SUBJECT: CATAWBA NUCLEAR STATION, UNIT 2 RE: DRAFT SAFETY EVALUATION  
FOR A PROPOSED AMENDMENT (TAC NO. MB1498)

## DRAFT

SAFETY EVALUATION BY THE OFFICE OF NUCLEAR REACTOR REGULATION  
RELATED TO AMENDMENT NO. \_\_\_\_\_ TO FACILITY OPERATING LICENSE NPF-52

CATAWBA NUCLEAR STATION, UNIT 2

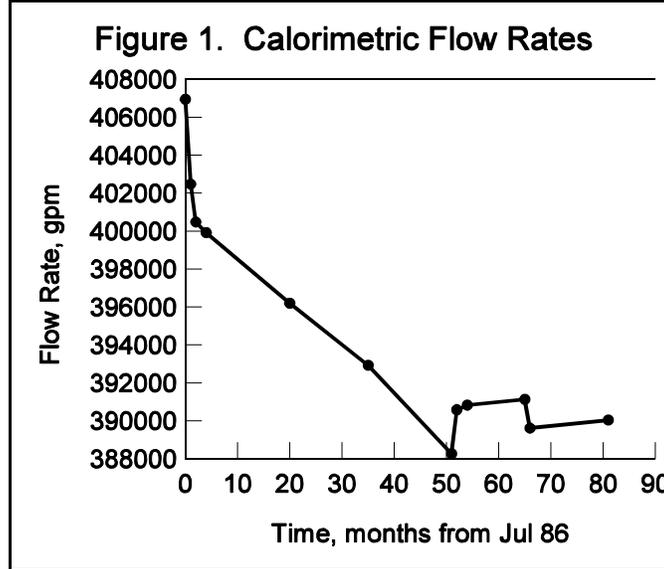
The calorimetric-determined flow rate values from Table 1 are plotted in Figure 1. The licensee excluded the July 1986 value because it was based on data obtained at 75 percent power (Reference 6), in contrast to the remaining values based on 98 percent or greater power. It used the remaining 11 values to establish its approved elbow coefficients. It proposes using the September and November 1986, and March 1988 values to establish elbow coefficients. The licensee believes the September 1986 and November 1986 values have less thermal streaming in contrast to the March 1988 value, which the licensee states "... contains a

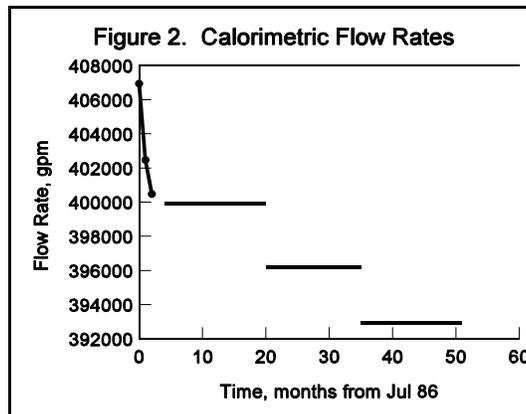
To assess these statements and their implications, we first assume the initial flow rate degradation is due to RCP impeller smoothing, as discussed in Section 3.2, below. Then we assume the later degradations are essentially due to physical changes during refueling outages and flow rate is essentially unchanged between outages. (This assumption is consistent with observed behavior.) This results in the Figure 2 representation of the early values.

licensee's model predicts this has little effect on RCS flow rate, which substantiates our judgement that SG tube plugging has little influence on flow rate during the first few months of operation. Since SG tube plugging does not significantly affect the flow behavior illustrated in Figure 2, we conclude that the apparent step flow rate decrease of 3700 gpm at 20 months is due to a combination of core reload and RTD bypass removal.

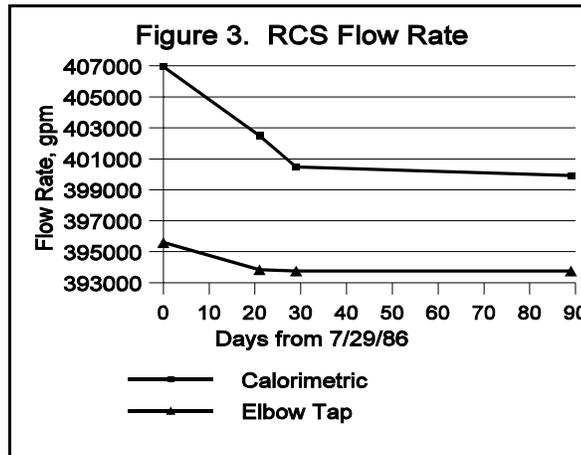
Consider the flow rate degradation illustrated in Figure 3, which provides the early calorimetric values and elbow predictions.<sup>3</sup> The calorimetric values reflect the downward trend illustrated in Figure 1, but the elbow values are constant after the initial value. (We are interested in the trend in elbow values, not the values for purposes of this discussion since the elbow information results from coefficients obtained using 11 calorimetrics.) Neglecting potential error due to uncertainty in the values and a bias due to using 11 calorimetrics, the change in elbow value during the first 21 days of operation is about 1750 gpm, a change we believe is due to RCP impeller smoothing, as identified in Section 2, above. Further, the elbow information implies there was little smoothing after 21 days. Since some impeller smoothing will have occurred before the Figure 3 information was obtained, on this basis the total smoothing effect will be greater than 1750 gpm.

Although the first calorimetric was made at 75 percent power, we note the trend is consistent with the second and third values and there is little inconsistency between the calorimetric and elbow trends, although the magnitudes are different. If we assume the calorimetric values are correct, then the flow rate decreases by 6500 gpm during the first month and, consistent with the calorimetric, is relatively constant during the next few months.

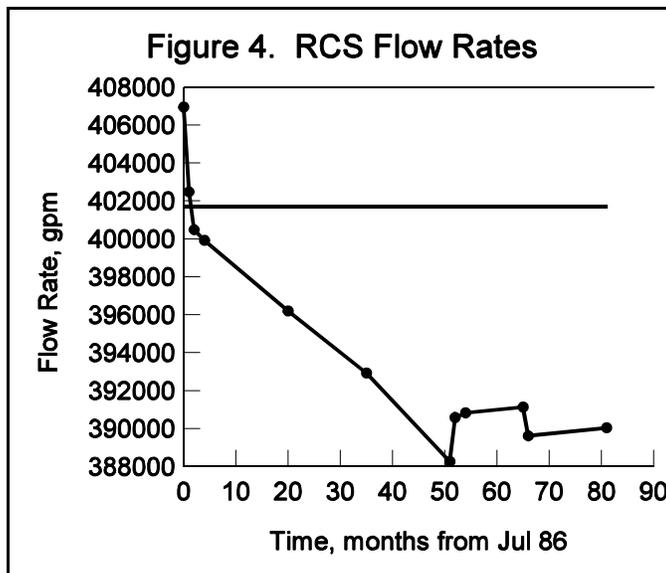
As illustrated in Figure 4 (References 2 and 5), the analytic model predicts an essentially constant RCS flow rate of ~401,700 gpm during the first few years of operation in contrast to the calorimetric determinations, which show significant variation.

There were 80 SG tubes plugged early in plant operation. The licensee's model predicts this has little effect on RCS flow rate, a reasonable prediction. However, the licensee did not address modeling changes associated with RTD bypass removal, and its model results do not reproduce the flow rate increase illustrated by the elbow response following manifold removal and as-expected from that removal. The licensee should ensure the model correctly represents these flow perturbations.
